Environmental Review Team Report

Environmental Review Team
Report
on

Colchester Commons
Colchester, Connecticut

May, 1982

Vegetation

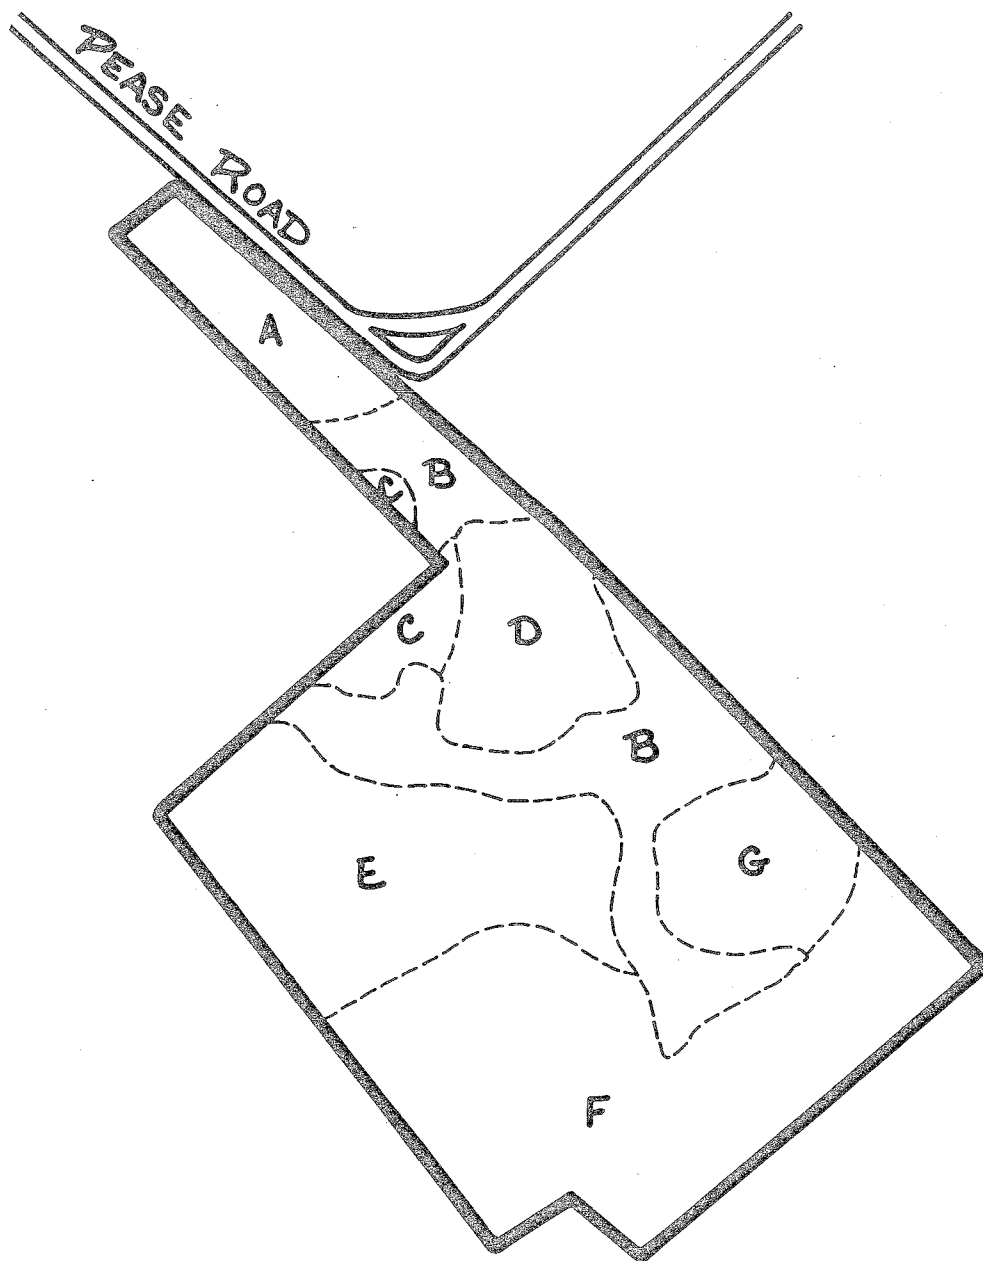
The tract of land for this proposed development may be broken into seven decernable vegetative types. Some of the vegetation boundaries follow the soil type changes and others are more dependent on soil depth. The general boundary lines are delineated on the accompanying illustration.

of yellow birch, black birch and American elm. The understory is mostly spice bush with coast pepperbush and some highbush blueberry. Herbaceous vegetation includes skunk cabbage and sedges in the more open areas. Since these areas will not be disturbed by the development, there should be no work done in them at this time. Once the development is established, light firewood thinnings by the people in the area would be the best management approach.

Most of these trees are fairly small in diameter and are not overcrowded. Care should be taken during development to displace as few of the red cedars as possible as they are the only natural conifers in the area. Some of this area is scheduled to be cleared as a parking lot for recreation vehicles, but the existing red cedars supplemented with additional plantings of white pine will make an attractive natural screen for the area.

There is little that can be done to improve this area, except to landscape the individual lots, removing broken trees and encouraging natural regeneration.

If thinned carefully, this will be quite a pleasing woodland setting.

The "Vista area" concept, although nice in the planning stage, could cause problems to implement. Just thinning the woods will promote a great deal of undergrowth which would soon negate the vista unless it was cut back on a bi-annual basis. Thinning, leveling, filling and planting grass could be very detrimental to the residual stand. Trees that have been growing under adverse conditions, i.e., overcrowding or dry conditions, are more readily damaged or killed when fill is added to an area.

Unfortunately, so much of the area has been cut so heavily that many of the lots will require some tree planting to achieve the planned affect of the woodland setting. There are seedlings and saplings that could be nurtured into developing good trees. Care should be taken to remove trees with open decay showing in the base, as they would have high risk of blowing over in a wind storm.
